SECTION 01 010
SUMMARY OF THE WORK

Bartow County Fire Station #9

PROJECT PARAMETERS AND CLARIFICATIONS –

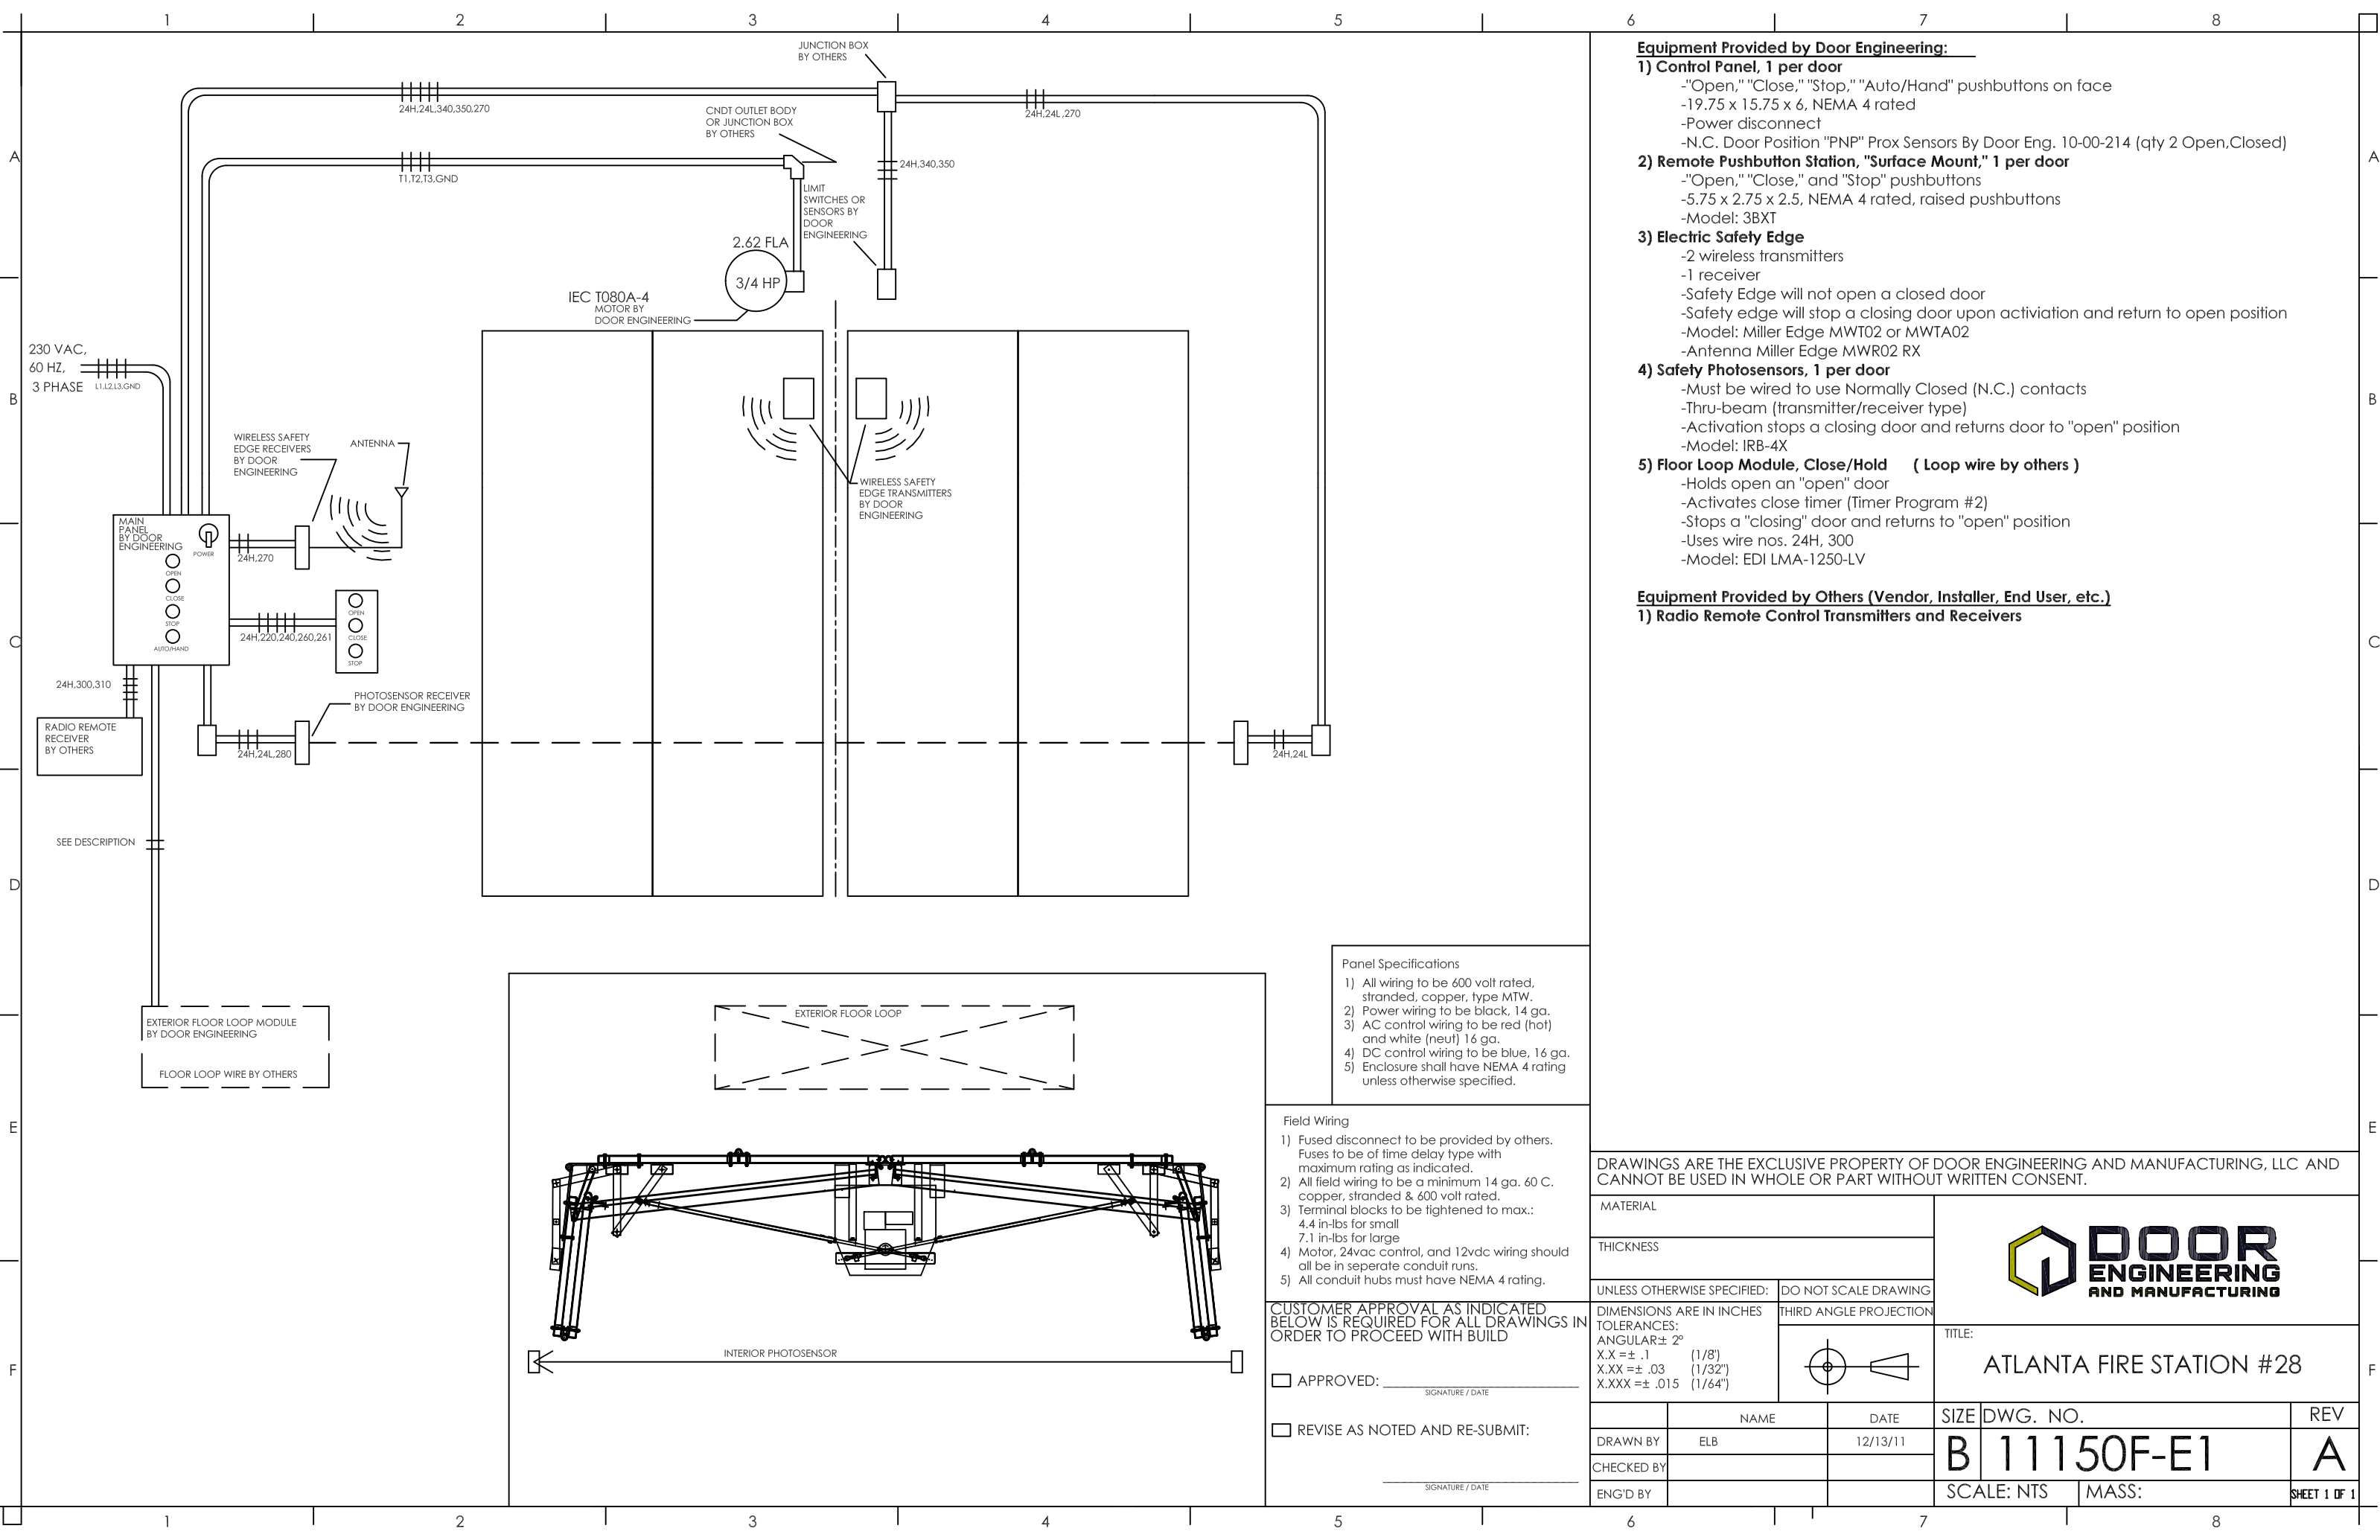
29. Utility Building and Fuel Center are not part of the Contract/bid.
30. Engine Exhaust system is to include Six (6) connections and three lines for the vehicle exhaust.
Verify layout with owner prior to providing shop drawings.
31. The following information is attached to the section OR posted on the FTP site and is to be included/coordinated as part of the bids:
 - i. Arch-top door shop drawing (as reference) provided by Door engineering and Manufacturing.
 - ii. Mechanical, Electrical, Plumbing updated drawings. (posted on FTP Site with July 23 date).
32. Provide two (2) sets of hot and cold hose bibbs inside the Apparatus Bay.
33. Below is the rendering of the proposed Fire Station exterior for reference.
